US 27/SR 1 - HAMILTON ROAD WIDENING
Project No. NH-017-1(20)
P.I. No. 322250
Troup County

Value Engineering Study Report
Preliminary Design Submittal

December 2007

ALTERNATIVE NO.: **P-1/A-1**

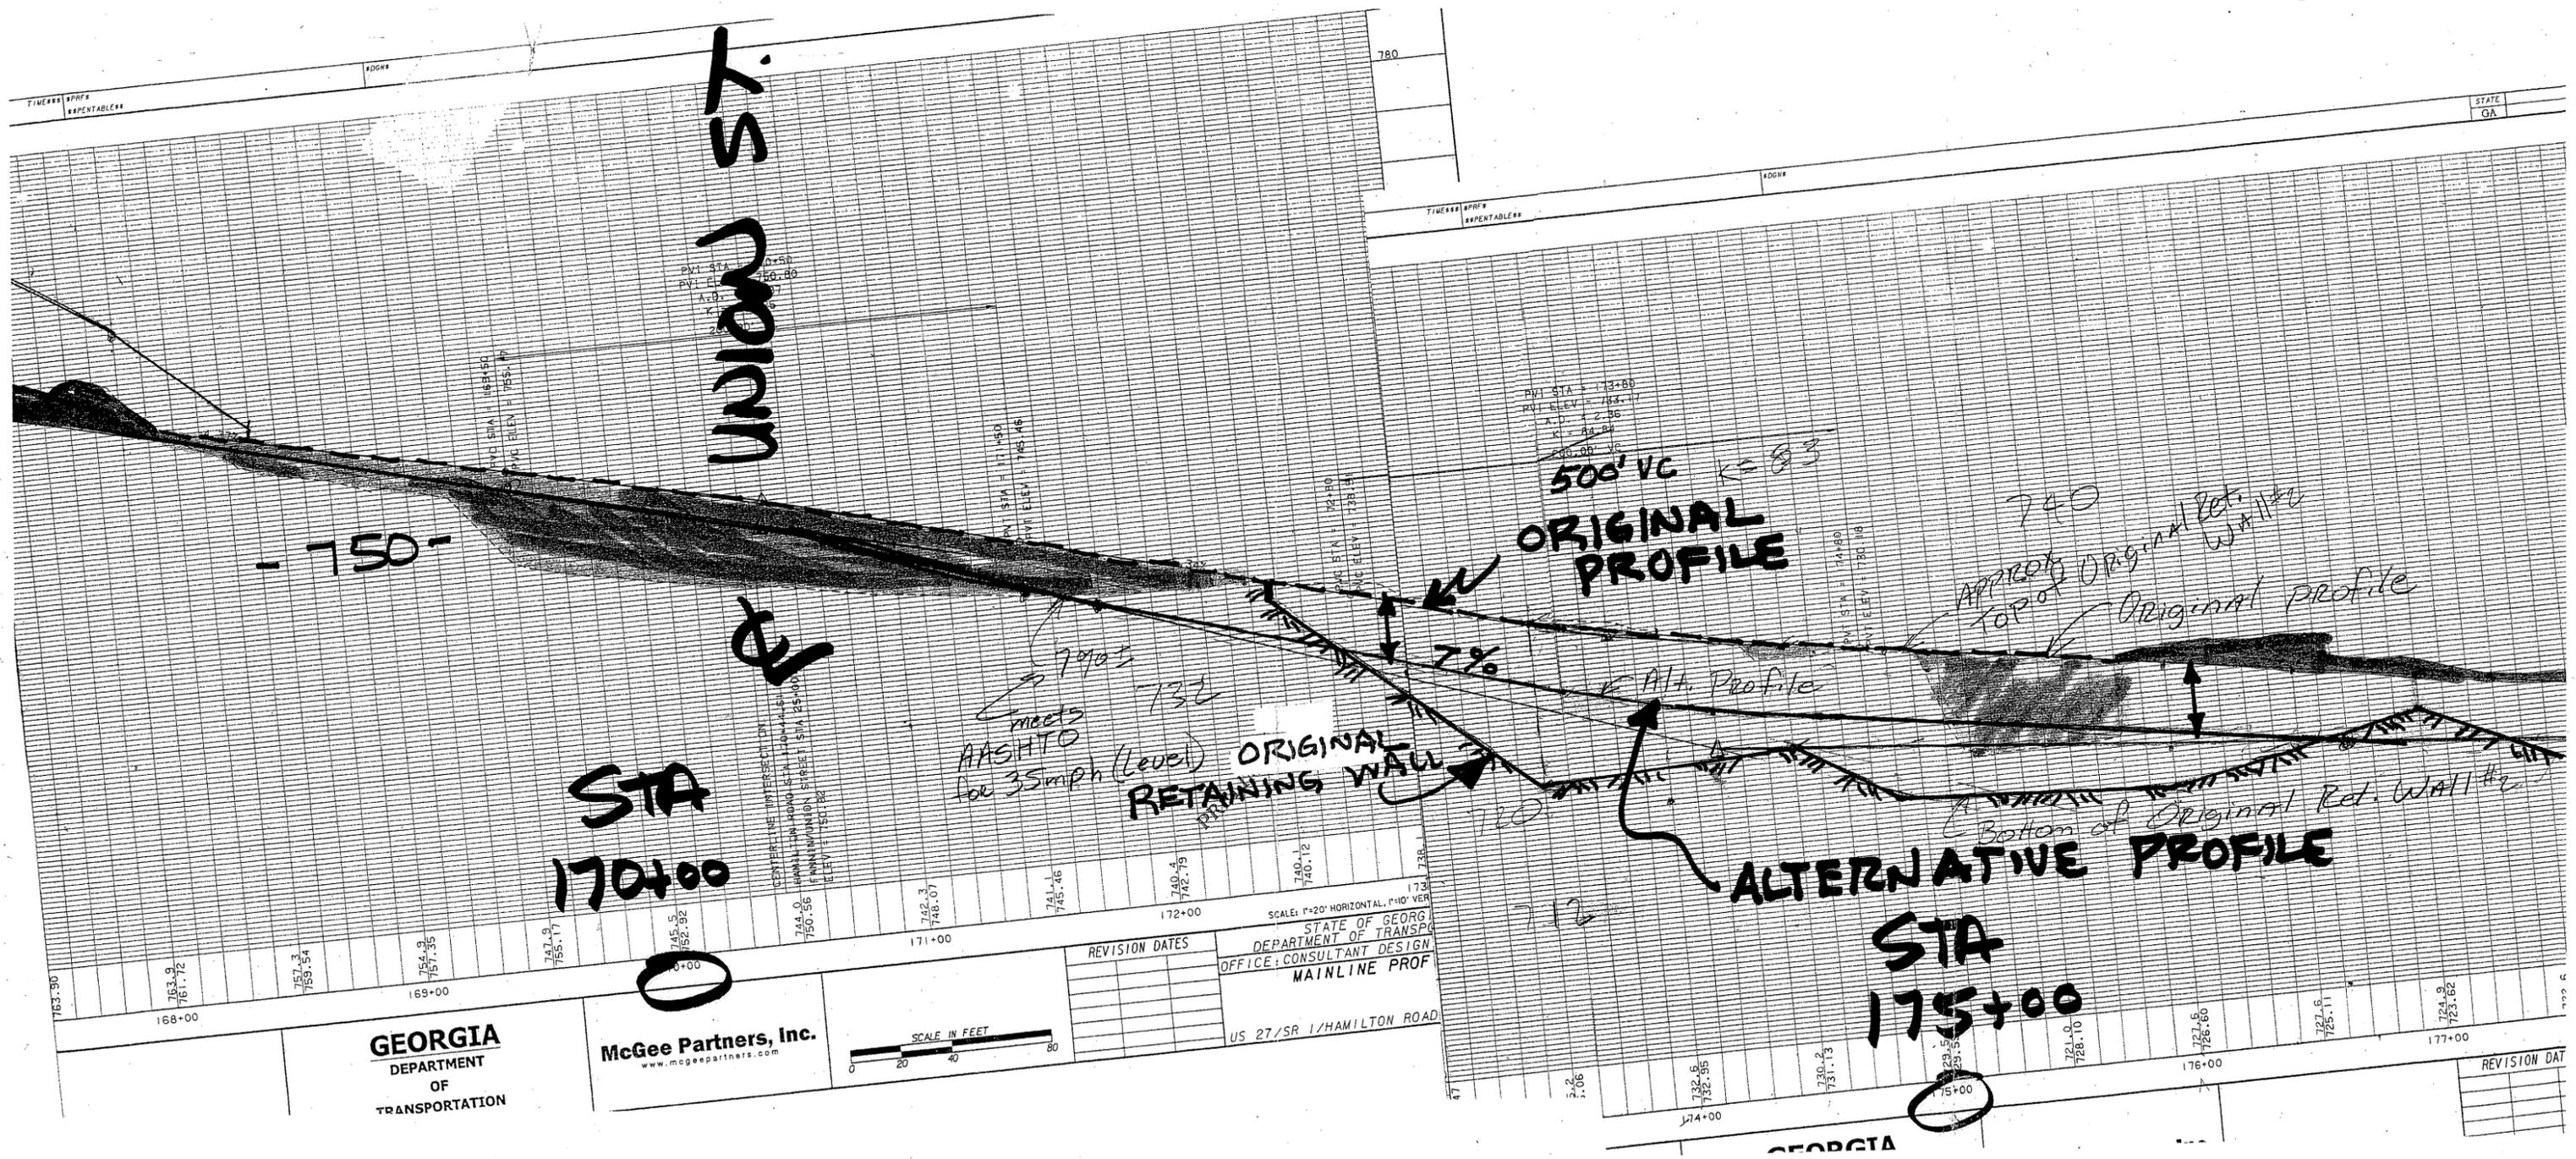
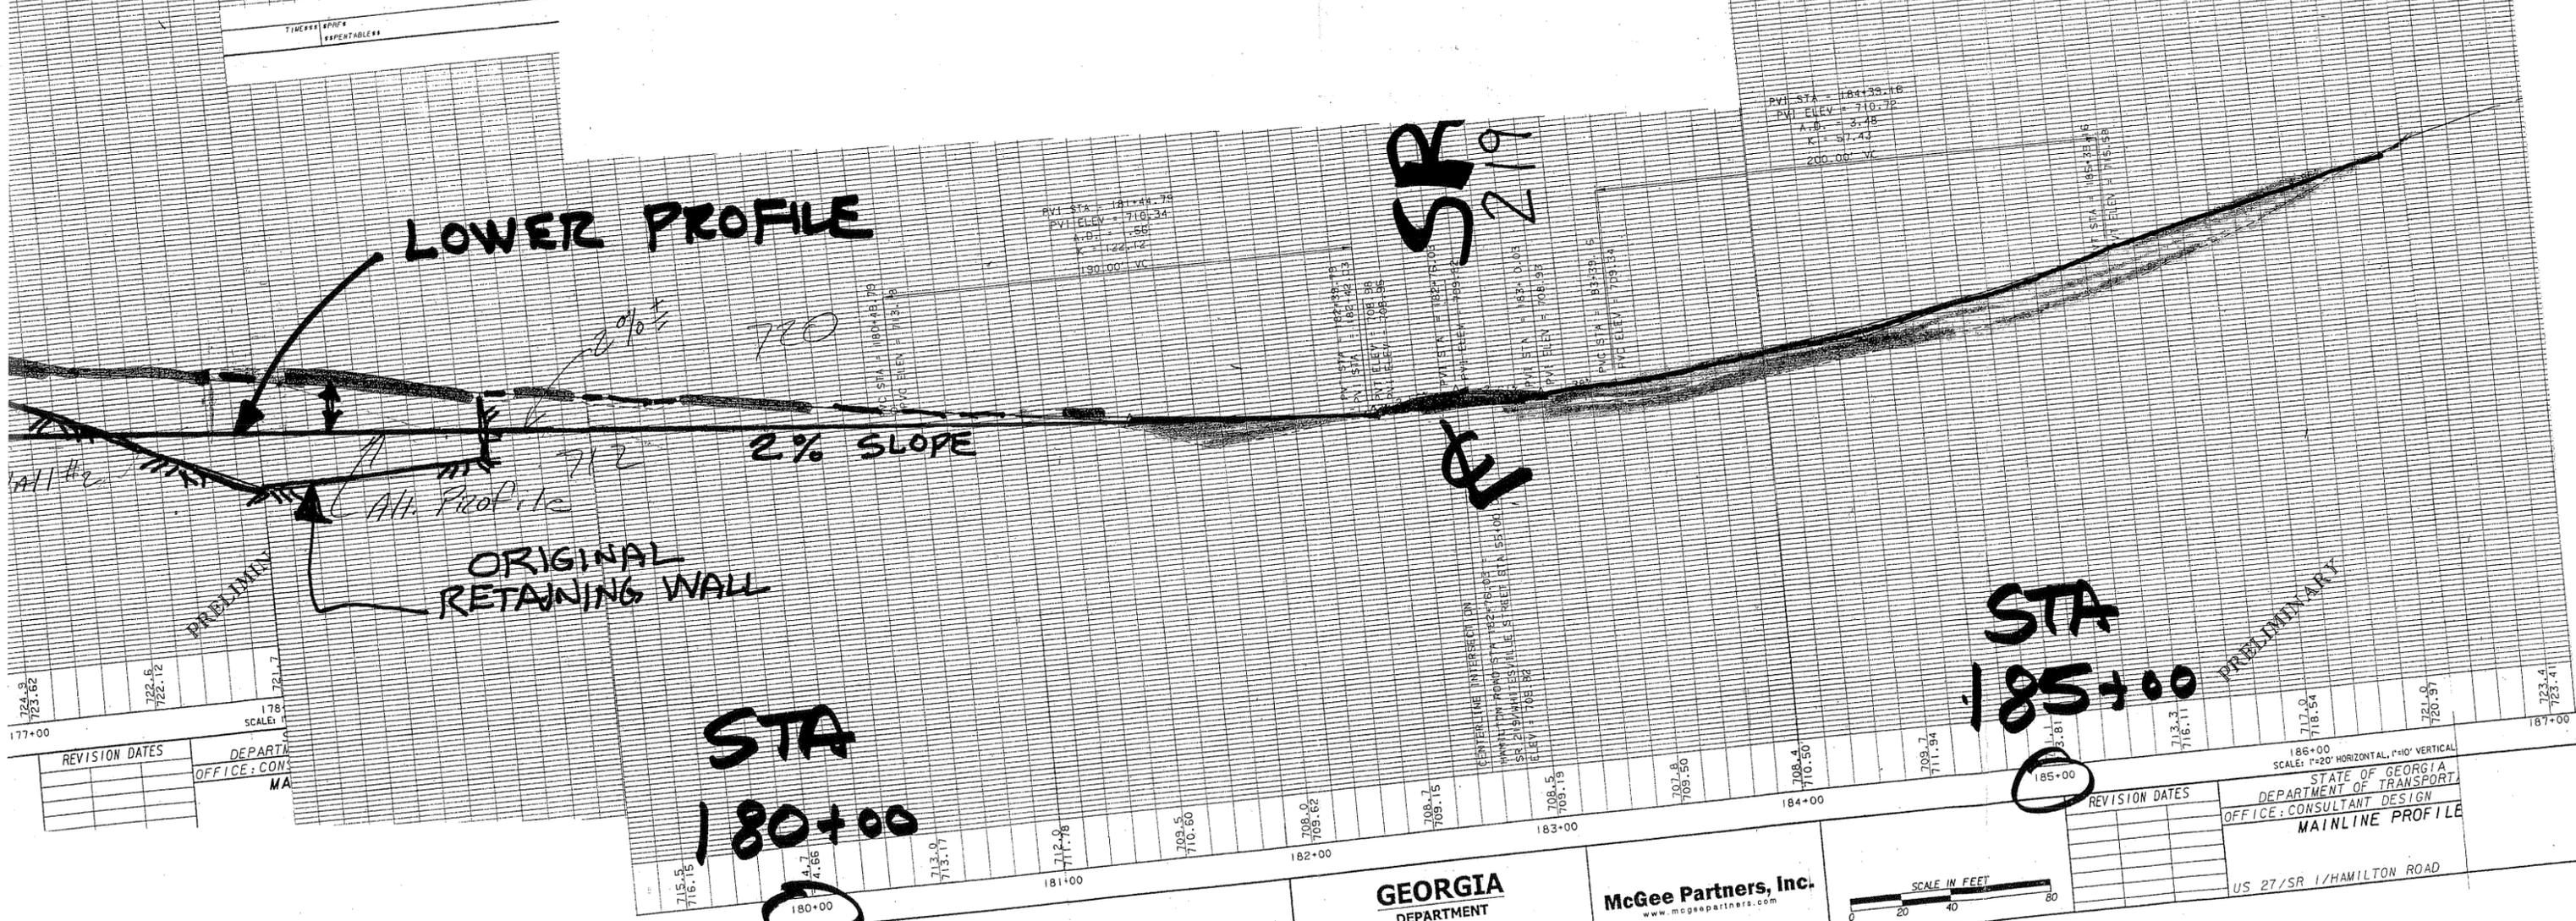
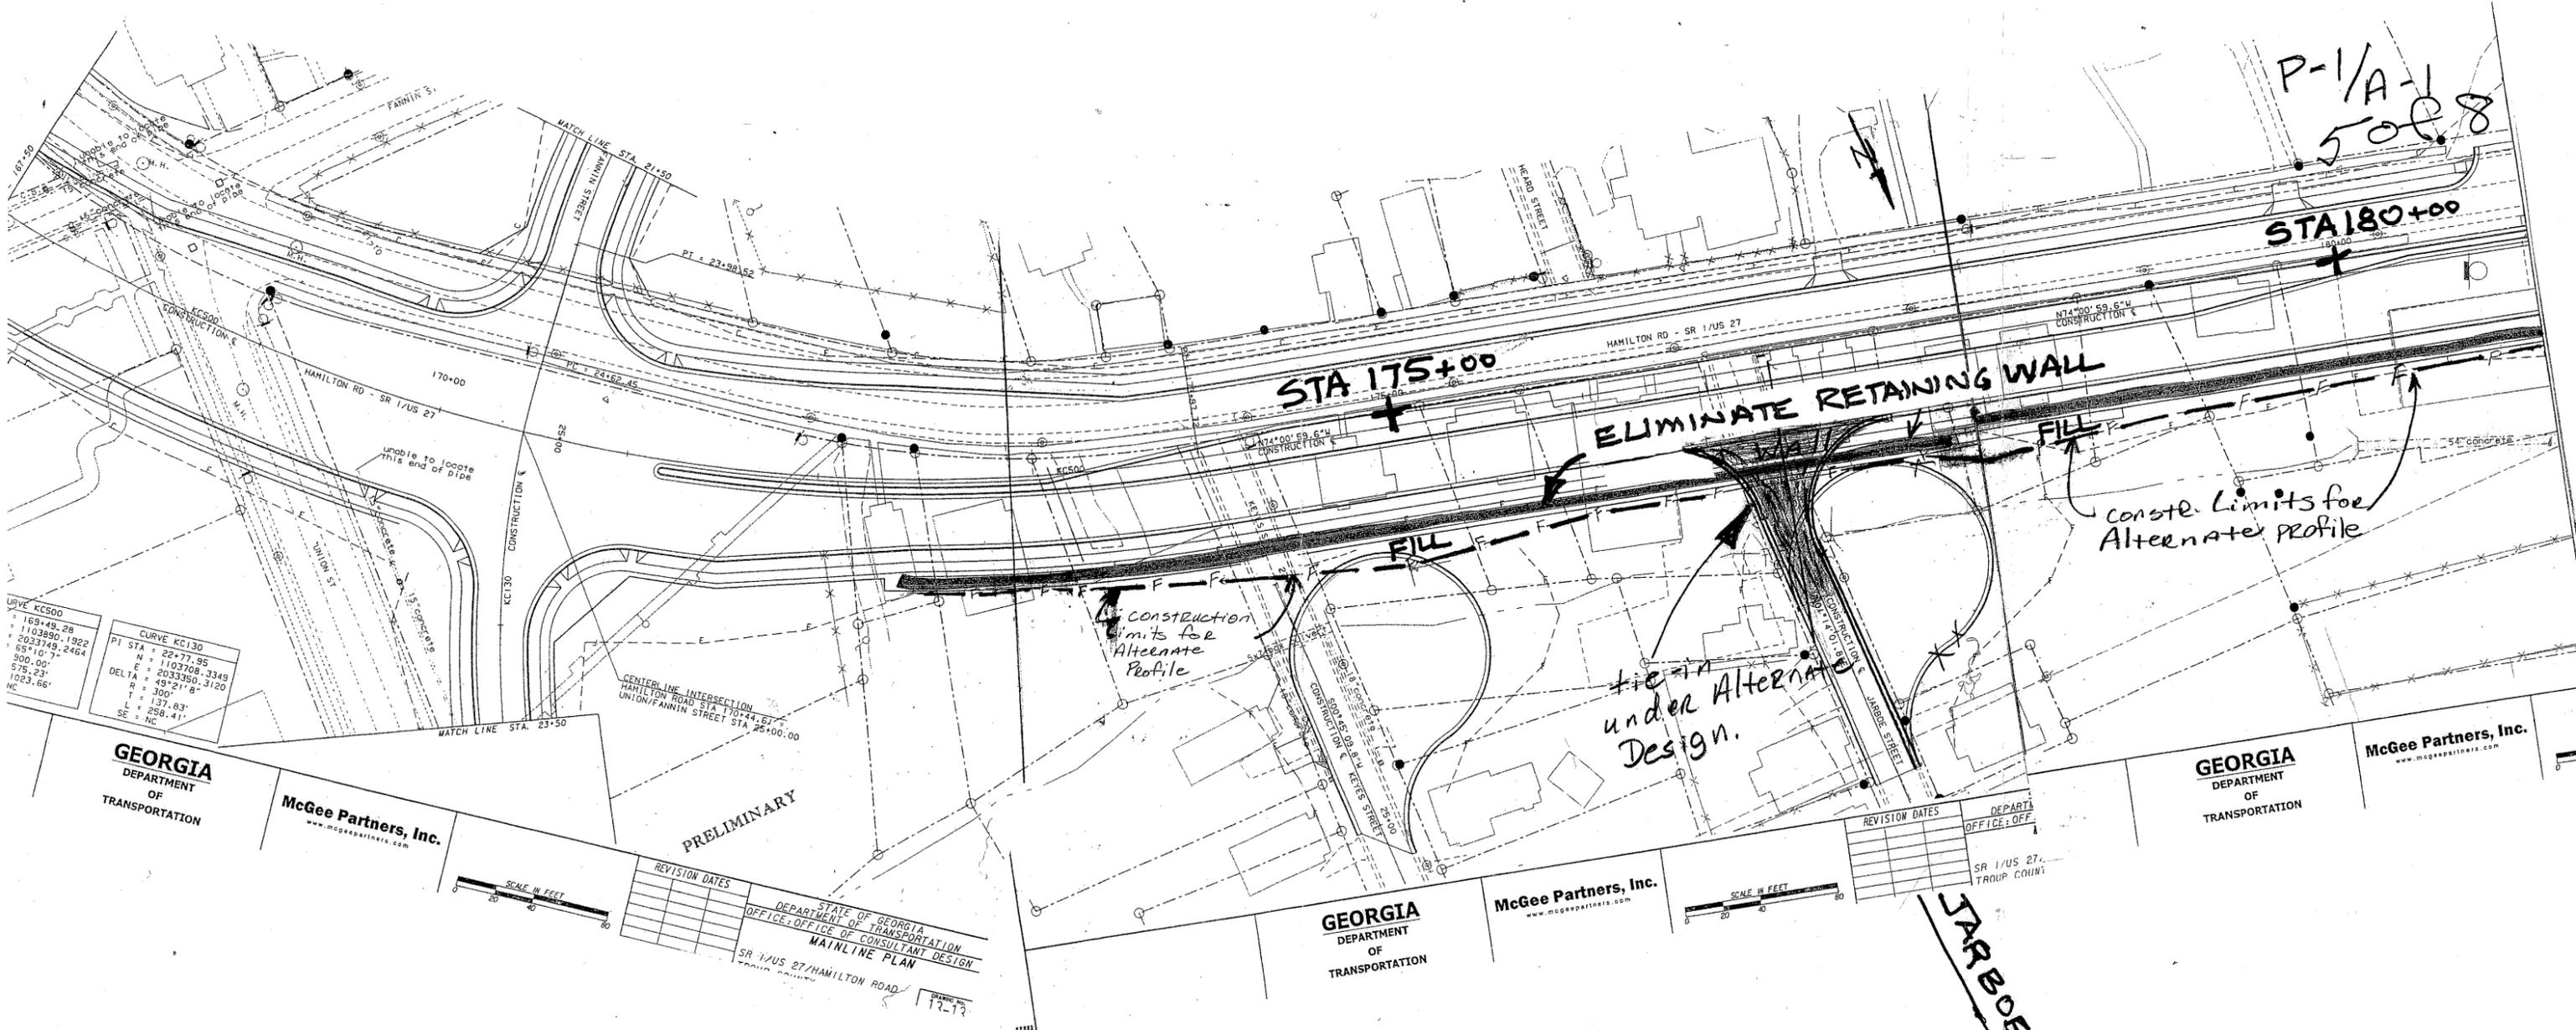
NOTES:
 • DELETE RETAINING WALL
 • LOWER PROFILE
